# ATTACHMENT D

4/26/2022

Thank you for taking the time to share your concerns about the proposed Wheaton Gateway Sketch Plan application. The following is a point-by-point response to the questions you submitted to staff on March 1.

Figure 1: Height Compatibility Exhibit

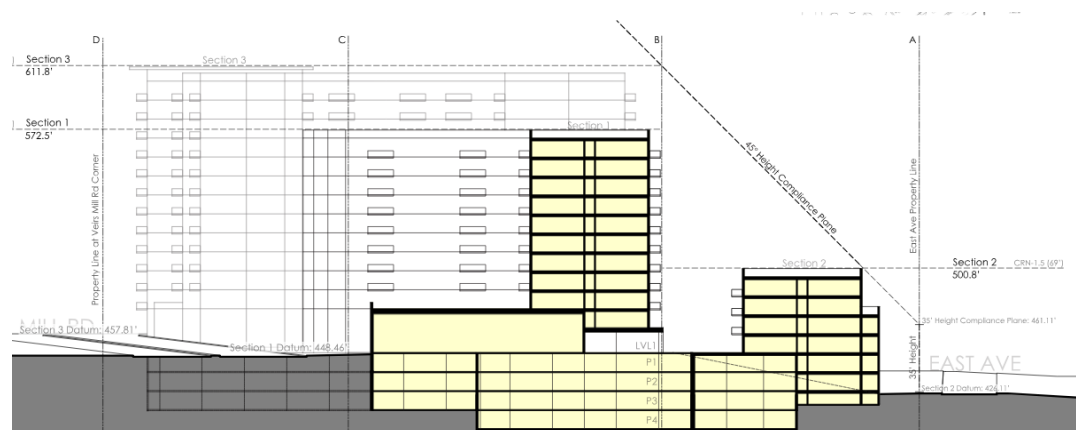
8. We also have concerns on how the proposed 124 foot height on Veirs Mill Road will transition on a 45 degree angle to East Avenue and still remain within the Commercial/Residential guidelines for properties confronting Residential properties – especially with an 18 foot elevation difference between Veirs Mill Rd. and East Ave. Will this “property” be considered one property, as proposed, or individual properties? Are the planners ignoring the CRN guidelines to move the project back to achieve a 45 degree angle?

The project will be one property one the future Preliminary Plan is submitted. The project meets the requirement per Height Compatibility 59. 4.1.8.B.3 for all the buildings confronting a R-60 zone that is vacant or improved with residential use. The applicant has updated the plans to show the 45-degree angular plane for compatibility.

The CRN zone does not have a setback requirement, but the building along East Ave has been designed with a 25'-33' setback from the road to provide further compatibility with the houses across the street. The 45-degree angular plane is being provided along East Avenue and Kensington Blvd where the Project abuts the R-60 houses.
